Submission to Northern Beaches Local Planning Panel Meeting – 7 May 2025

**Re: DA2024/1376 – Subdivision of one lot into two including demolition works, new driveway and carport
7 Cooleena Road, Elanora Heights, NSW**

Figure 1 – Photos of land movement at 5A Cooleena Road – immediate adjacent to indicative dwelling proposed.

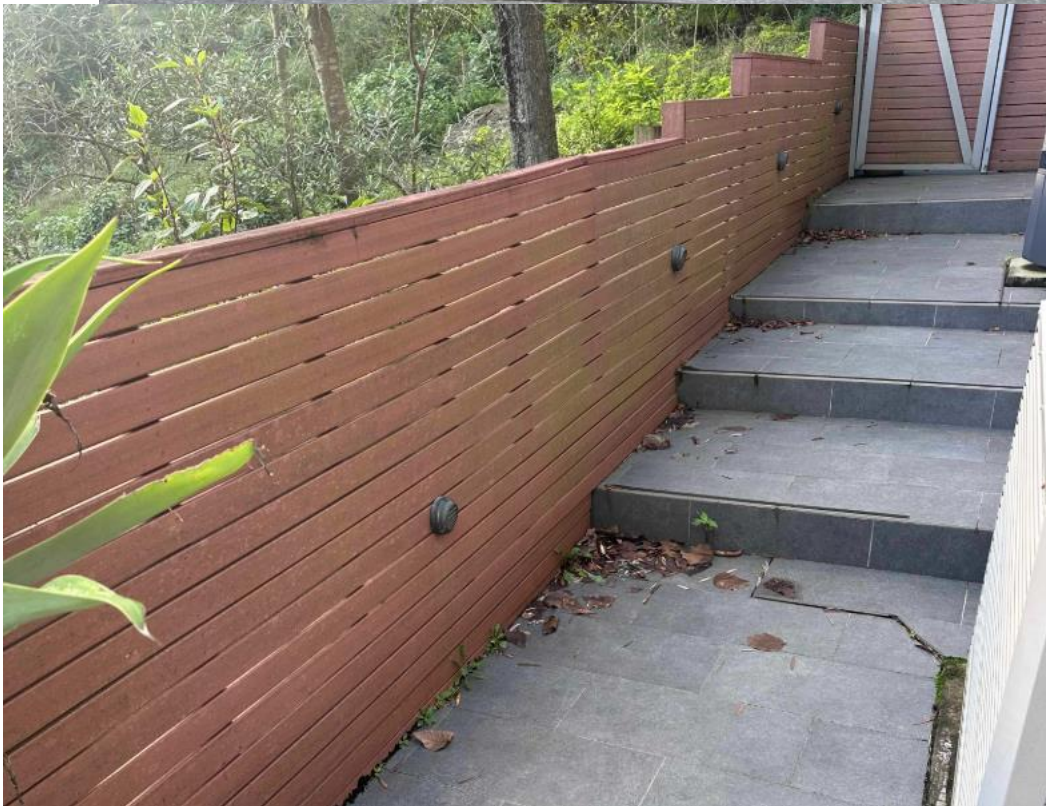
It is queried how a very similar proposal can have been refused given the geotechnical and stormwater risk and is now recommended for approval. My clients have provided me with photographic evidence to support the further landslip impacts on their property, which is located immediately adjacent to the indicative dwelling. The photos overleaf demonstrate the increasing landslip which is occurring on site and should be avoided on the subject site. The slip area is falling in a south-westerly directions towards the side and rear of the subject site.

Note the side boundary fence with the subject site

Note the slip area is to the south-west – the subject site is just past the swimming pool fence.
